Justification for Class III Permit Modification September 2005, SWMU 152, au 1295 Building 9950 Septic System, Coyote Test Field

Justification for Class III Permit Modification

SWMU 152

**Building 9950 Septic System, Coyote Test
Field**

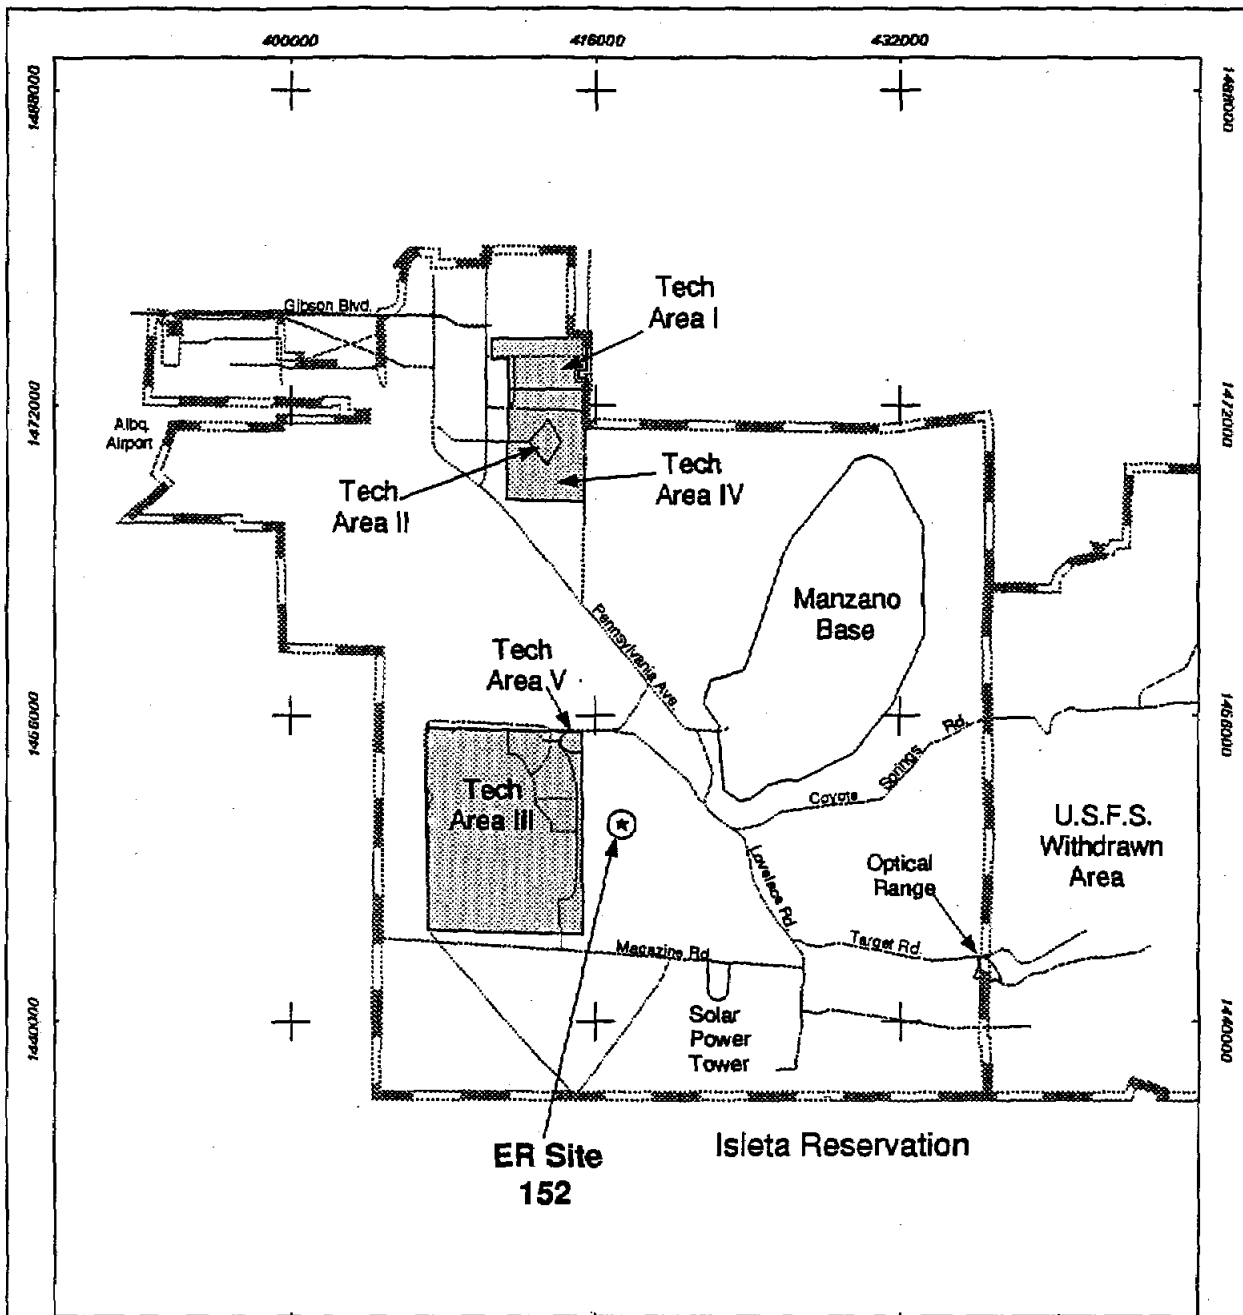
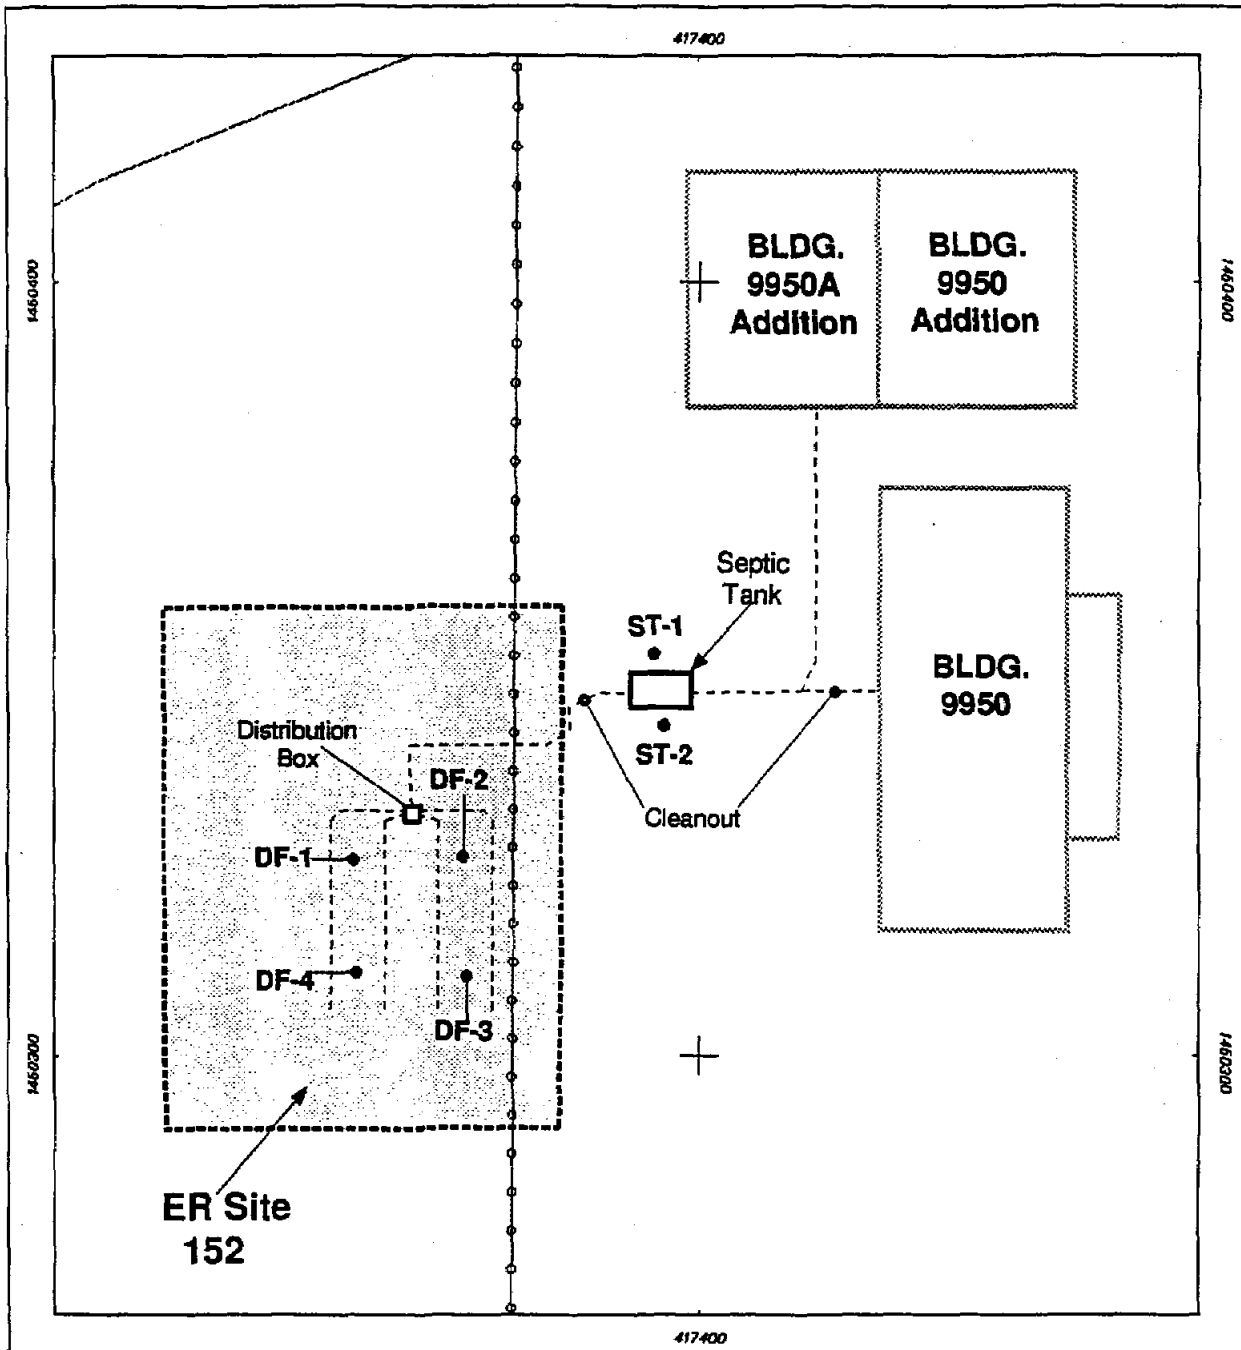
1. **The maps shown in Figures 1-1 and 1-2 are labeled "draft". See general comment 1.**

Response: Replacement Figures 1-1 and 1-2 without the word "draft" are provided in Attachment G.
